**Indonesia  
Expert Dispatch Scheme  
Dam Design and Construction  
Advisory Services**

**Completion Report  
Data Book**

Name of Dam : Keureuto Dam

Name of Dam : Rukoh Dam

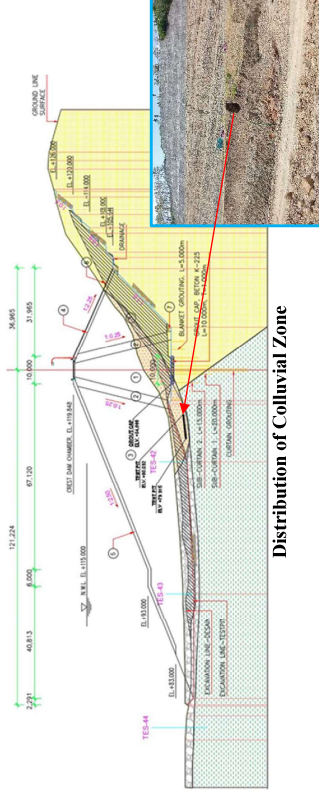
The surface slope sliding occurred at the upper portion of the excavated slope of original inclined intake structure. It is supposed that the sliding occurred at the surface of the slope and the slip line may be not deep. However, the sliding trace is remaining at the excavation slope surface so that the sliding portion must be protected from the further sliding after impounding.

In accordance with the information from the Site Engineer, the slope with H:V=1:1.0 keep stability so that it is supposed that the slope failure occurred due to steep slope (H:V=1:0.7).

The protection measures against a further sliding shall be provided. It is considered that counterweight by means of embankment materials (random material) or slope protection/frame works with rock-bolts.

Considering the permanent protection of slaking of claystone on the slope surface, it is supposed that the counterweight method may be preferable. The counterweight embankment may be affected the intake structure, so the area to be placed the counterweight shall be examined detail and designed retaining wall surrounding intake if necessary.

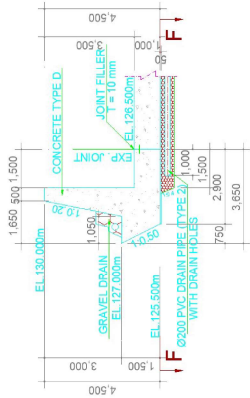
In general, drain grid system under the slab concrete and back drain behind the side wall with weep holes are designed but in Keureuto Dam, under slab drain is provided only one line at the center of 30m wide slab, and there is no drain system behind the side wall.

Since the spillway concrete was already placed, ground water may be released via weep holes newly drilled on the slab concrete and side wall concrete. Location of weepholes are:

- Slab concrete : as mentioned above section
  - Side Wall : one hole per 5m<sup>2</sup>
- Diameter of drain holes are 5cm.

(3) Boulder/Sand/Clay flow into the Spillway Channel

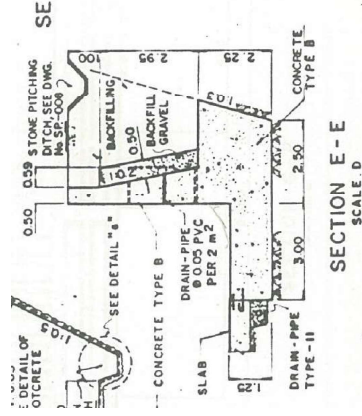
Many boulders/sand/clay observed on the spillway channel and in the stilling basin. The site engineer said that boulders and sediments were come into the channel from both side slope of spillway channel. Such solids (boulders and sediment) will be a cause of erosion of spillway concrete. It is important to minimize the flowing the boulders and sediments into spillway channel.

One of protection method is lowering the backfill surface, maybe 1 m below from the top of side wall so as to the boulders and sediments can be stopped on the backfill portion. When the backfill surface is lowered, it is anticipated that rainwater runs on the surface of backfill and erodes the backfill material. As a countermeasure against an erosion of backfill material by rainwater, the spillway channel backfill surface was covered with concrete stairs to protect the erosion and dissipate the energy at the Jatibarang Dam. The stairs is utilized as maintenance path.

The other way is installing drainage channel on the surface of backfill. The water can be flow down the sediments with downstream. Bili-Bili dam applying this system since the slopes on both sides of the spillway channel are composed with solid rocks (diabase/diorite).

(4) Right Side Wall of Stilling Basin

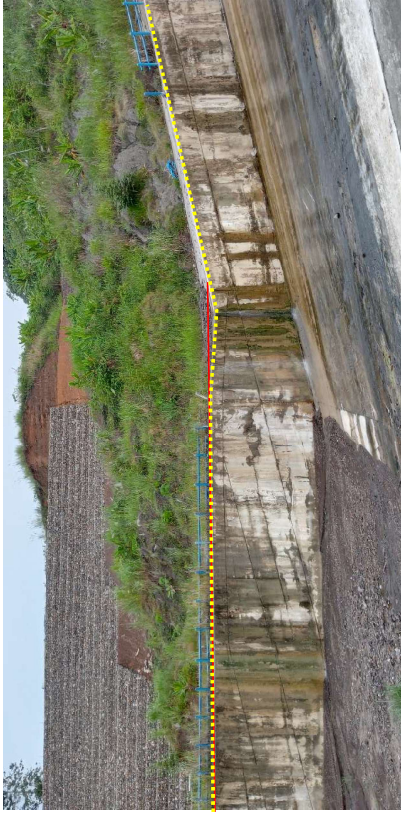
It is supposed that the right wall of stilling basin was not constructed as design as shown in photo below. Sediments has flow into stilling basin from this portion.

It is recommended that this portion should be repaired as designed.

### 2.3 Seepage Measuring Device (V-Notch)

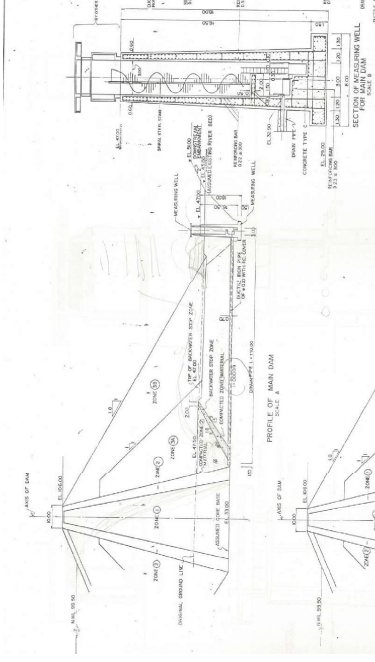
The Site Engineer proposed to raise up the position (elevation) of seepage measuring device (V-Notch) to flow the seepage water by gravity, because the downstream water level is higher than designed seepage measuring device.

However, it is not recommendable because a seepage water collecting system (backwater stop zone, refer to following figure) was not installed in Keureuto Dam.

- ◇ Set the V-Notch at original elevation.
- ◇ Provide Measuring Well Tower to protect the river water flow into V-Notch, and
- ◇ Install a drain pump which runs automatically when water level of the drain pit (downstream of V-Notch) reach to the setting position.

The capacity of pump shall be set depending on the expected seepage discharge examined by means of seepage water analysis including rainwater on the downstream slope.

#### 2.2 Seepage Measuring Device (V-Notch)

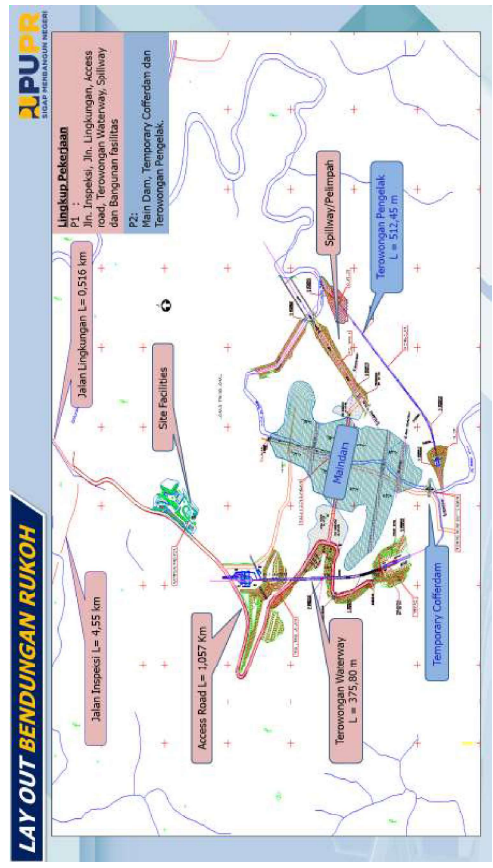
Issue of seepage measuring device is same as Keureuto dam. The Site Engineer proposed to raise up the position (elevation) of seepage measuring device (V-Notch) to flow the seepage water by gravity, because the downstream water level is higher than designed seepage measuring device.

However, it is not recommendable because a seepage water collecting system (backwater stop zone, refer to following figure) was not installed in Lukkoh Dam.

- ✧ Set the V-Notch at original elevation,
- ✧ Provide Measuring Well Tower to protect the river water flow into V-Notch, and
- ✧ Install a drain pump which runs automatically when water level of the drain pit (downstream of V-Notch) reach to the setting position.

The capacity of pump shall be set depending on the expected seepage discharge examined by means of seepage water analysis including rainwater on the downstream slope.

**Relationship between Dam Height and Embankment Period (actual record in Japan)**

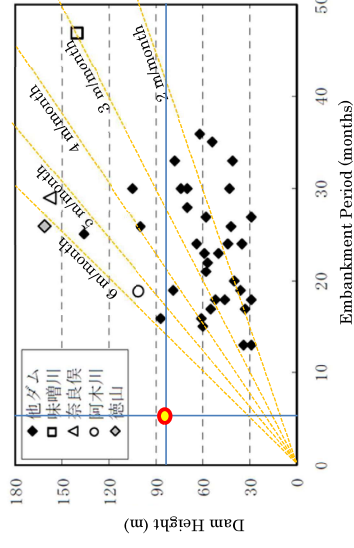
According to the Site Engineer, the embankment works will start from July 2023 and completed at the end of November 2023 so that the working day will be 150 days only. Since the dam height is 87m, daily embankment height shall be 60 cm/day. The core embankment will be performed as below:

Therefore, even if two layers of core were embanked a day, this plan will not be able to achieve this plan. Furthermore, extra embankment will be required additionally. This plan, therefore, is unrealistic because Ache region will enter the rainy season from now on and the workable days for core embankment will be limited in order to ensure the quality of the core (the number of workable days that is good for core embankment will be shortened).

Following figure shows actual records of embankment speed in Japanese fill type dams. As shown in the figure, the fastest embankment speed in Japan is 6m/month, but at Keureuto Dam, it is planned to be 17 m/month.

The implementation plan should be revised after considering the workable days fro core embankment, settlement of core due to rapid construction of core and the time required for field tests, especially field permeability tests.

## 3. Additional Information: Slope Failure at Left Cut Slope of Spillway on Sep. 19, 2023

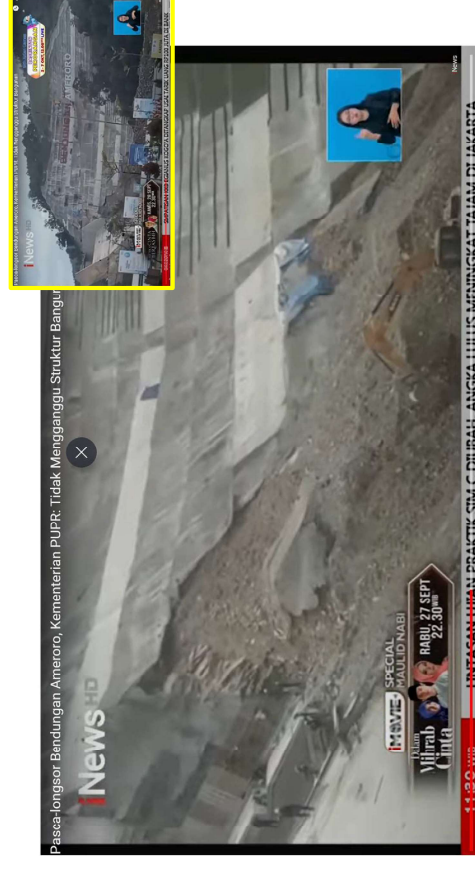
On September 19, 2023, slope failure occurred at left cut-slope of spillway chute. <https://www.youtube.com/watch?v=pEY0wcf5X4>

## 2.4 Seepage Measuring Devices

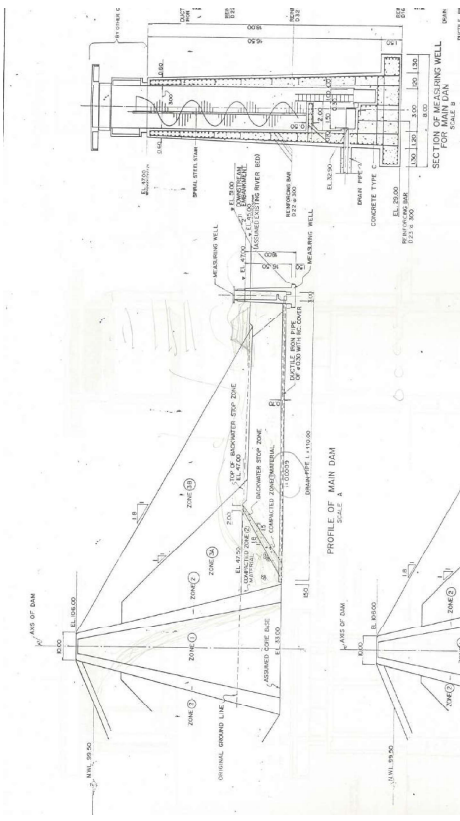
In the original design, outlet elevation of Seepage Measuring Device had been set at lower than river water level so that the counter water from the river will flow into the device and cannot measure the seepage discharge properly. To prevent counter water, V-Notch may be modified in 2 ways namely, 1) raise v-Notch elevation or 2) provide seepage measuring well (tower) for v-Notch.

Current design of the seepage measuring device will be modified as follows:

- ❖ Set the V-Notch at original elevation.
- ❖ Provide Measuring Well Tower to protect the river water flow into V-Notch, and
- ❖ Install a drain pump which runs automatically when water level of the drain pit (downstream of V-Notch) reach to the setting position.

Gambar 10. Bidang Lereng Spillway STA 0+140, (SF = 0.705).

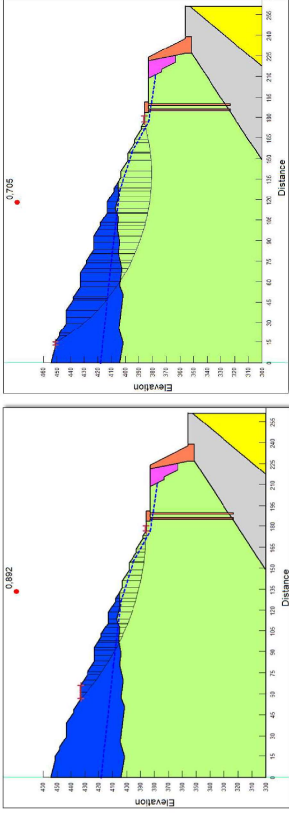
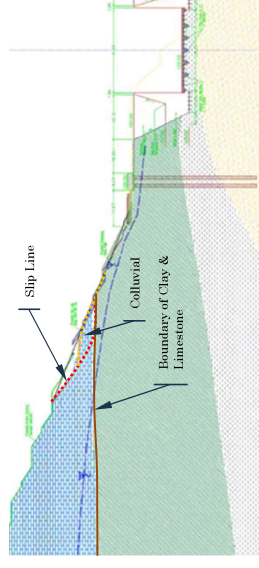
It is supposed that the initial sliding occurred at the boundary of Scaly Claystone and lime stone strata. The ground water is observed along upper portion of Scaly Claystone and due to the excavation for spillway, the stress was released and then swelling of scaly claystone was accelerated at the geological boundary. Since the strength of swelled scaly claystone is very small, it is assumed that the sliding occurred along the swelled scaly claystone. Furthermore, it can be estimated that the landslide has been gradually expanding to upstream, since the boundary is downward towards upstream.

The Consultant of supervision made an stability analysis applying circular slip method and the estimated slip-line was crossing the geological boundary. However, if the cause of sliding is swelling of scaly claystone at the boundary, the slip-line might be included the boundary (refer to following figure).

Considering the mechanism of the sliding, it is important to increase the resist forth at the toe of sliding mass (at geological boundary). It is effective providing a bore piles that penetrating geological boundaries/slip line at the toe of slip-line or installing ground anchor with concrete wall (or concrete frame) or providing counter weight (embankment) covering the geological boundary.

### 3.1.2 Currently Adapted Design against Foundation on Colluvium (Alternatif 2 Dengan (Secant Pile))

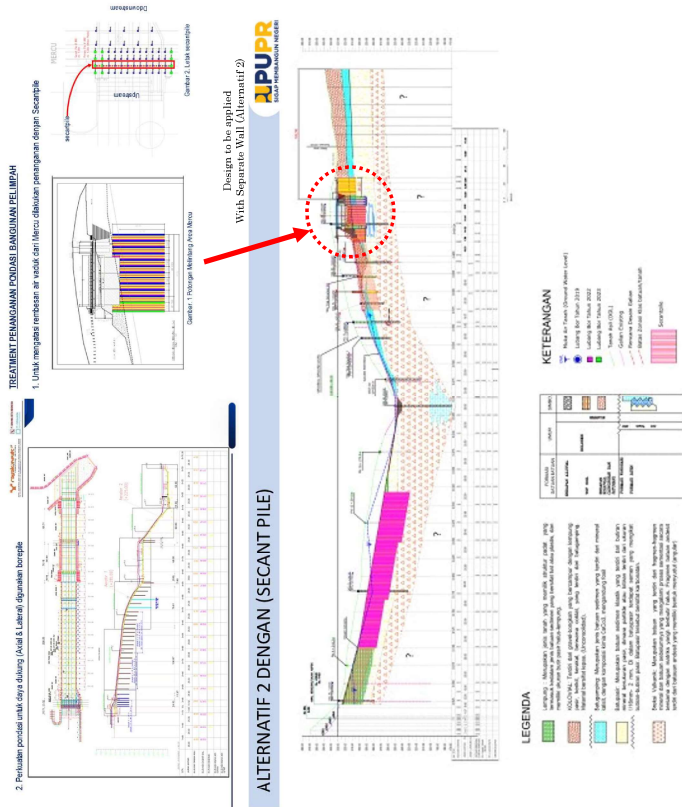
In the currently adapted design, the colluvium layer remains as foundations of spillway and right abutment of dam. As a countermeasure for spillway foundation, a Secant Pile (bentonite-cement wall) as a continuous underground wall is applied to reduce seepage flow and to prevent piping, besides the concrete bore pile for the spillway (see figures below). To secure a water tightness in the colluvium, a continuous underground wall has been proposed applying Secant Piles using very deformable bentonite-cement.

Note 1 : The design strength of the colluvium is  $c=24.5kPa$  and  $\phi=16^\circ$ , regardless of whether it is on the left or right bank. This value generally corresponds to the strength of a soft clay layer. However, since shear planes develop in the clay of the slip layer, the internal friction angle may be less than  $10^\circ$ .

- ✓ A detailed geological survey should be carried out again, to confirm the distribution/character of colluvial and the existence and shape of the slip layer, then the design should be modified in accordance with the actual conditions.
